WCAP-15807-NP-A
Revision 0

Westinghouse Control Rod Ejection Accident Analysis Methodology Using Multi-Dimensional Kinetics

SUBJECT: ACCEPTANCE FOR REFERENCING OF TOPICAL REPORT WCAP-15806-P
AND WCAP-15807-NP, "WESTINGHOUSE CONTROL ROD EJECTION
ACCIDENT ANALYSIS METHODOLOGY USING MULTI-DIMENSIONAL
KINETICS" (TAC NO. MB4521)

Figure 3.5 Core Average Power Sensitivity

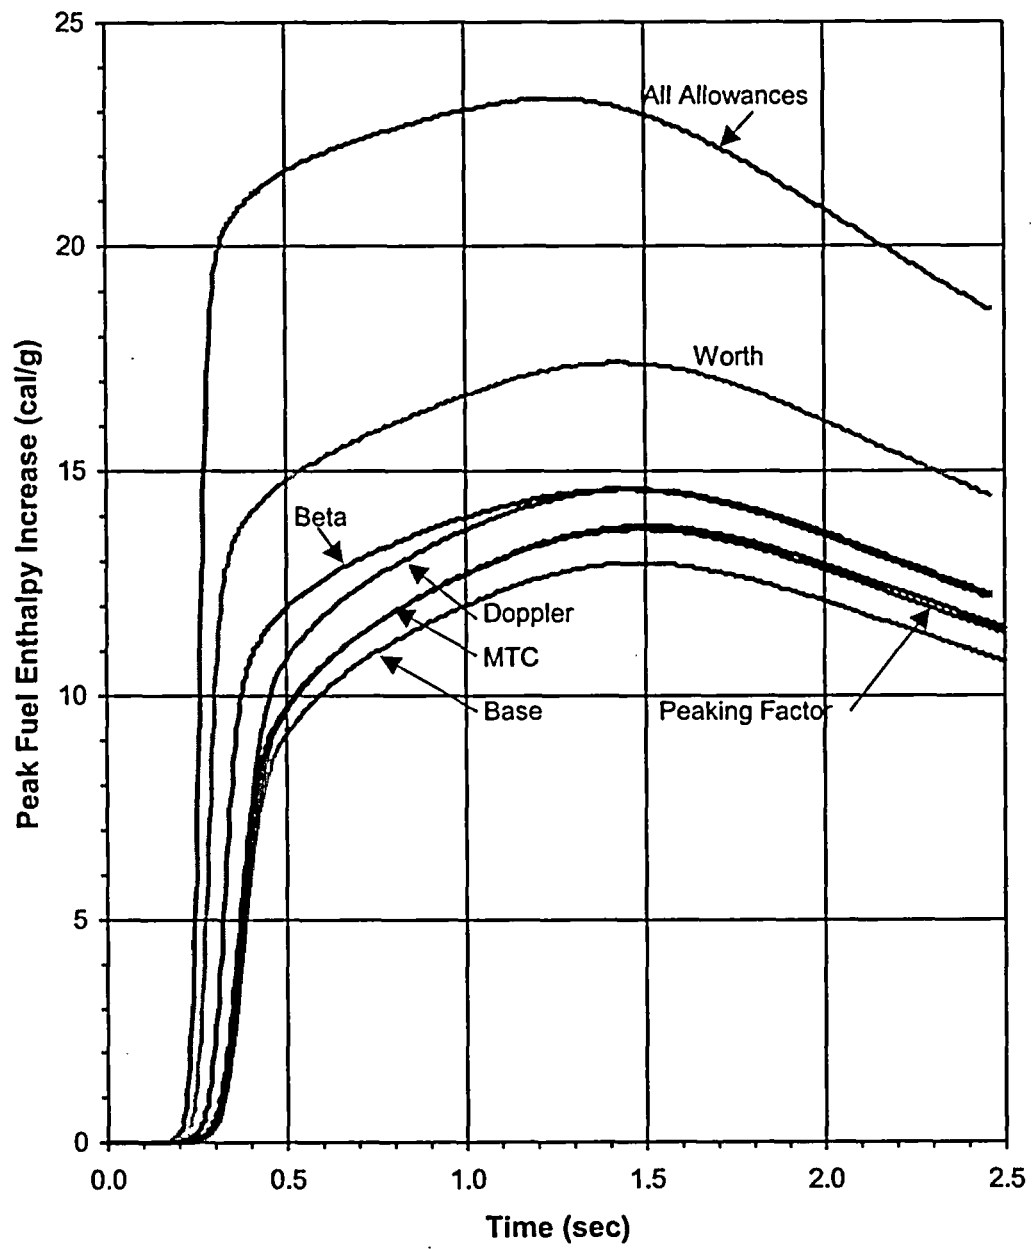
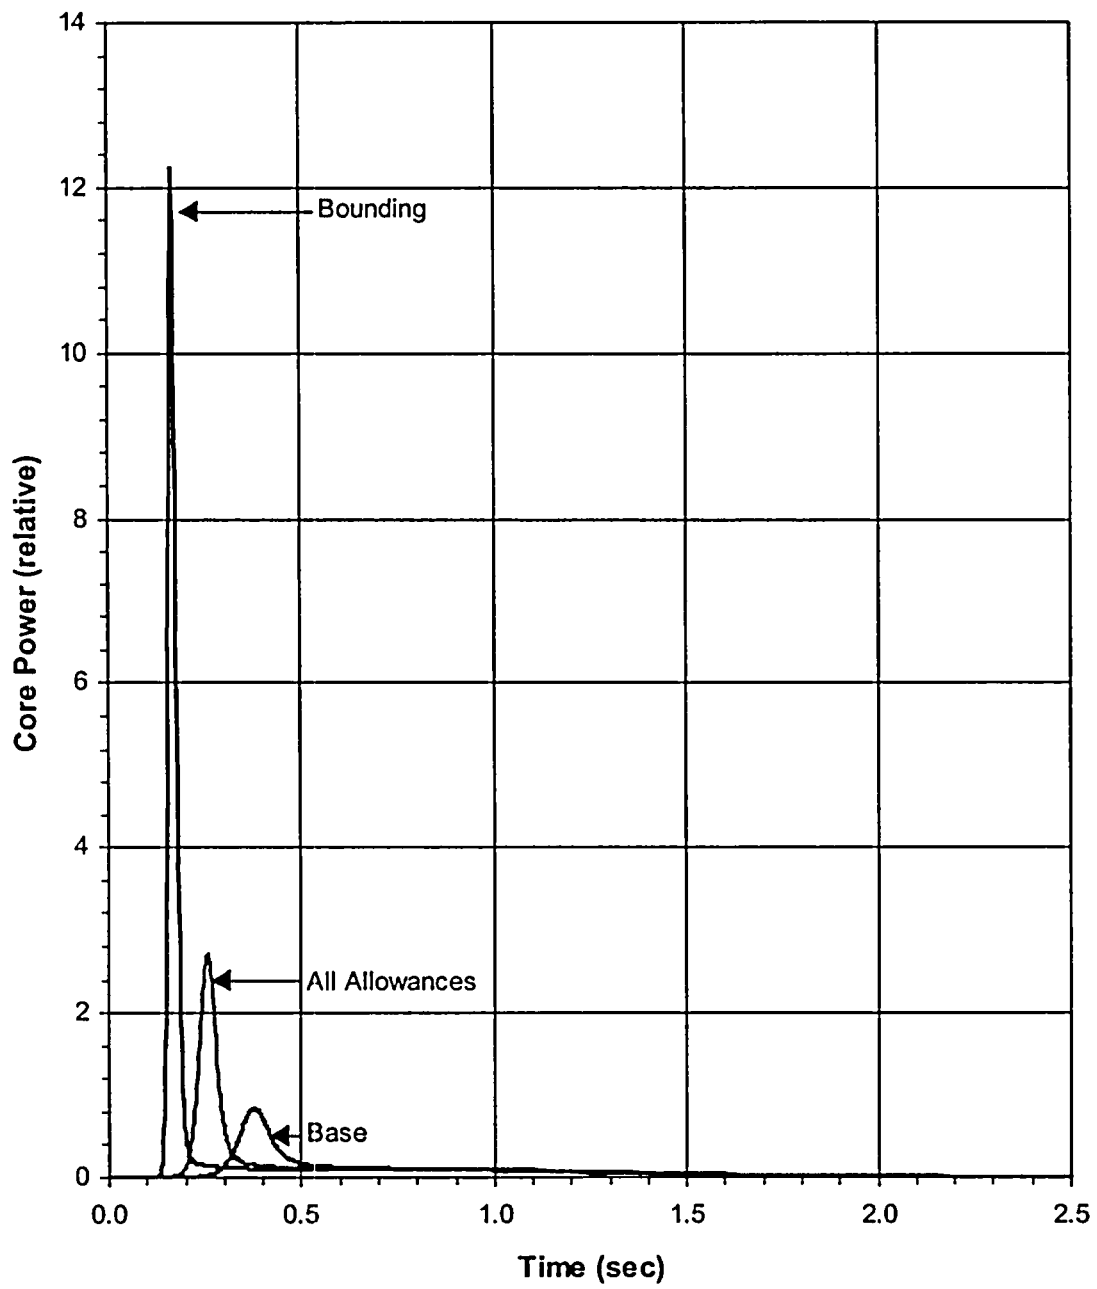
8. Provide confirm source of data in Figures 3.5 and 3.6.
- R.8 The data provided in Tables 3.3 and 3.4 are from the calculations that are documented, following internal QA procedures, in internal Westinghouse calc notes.
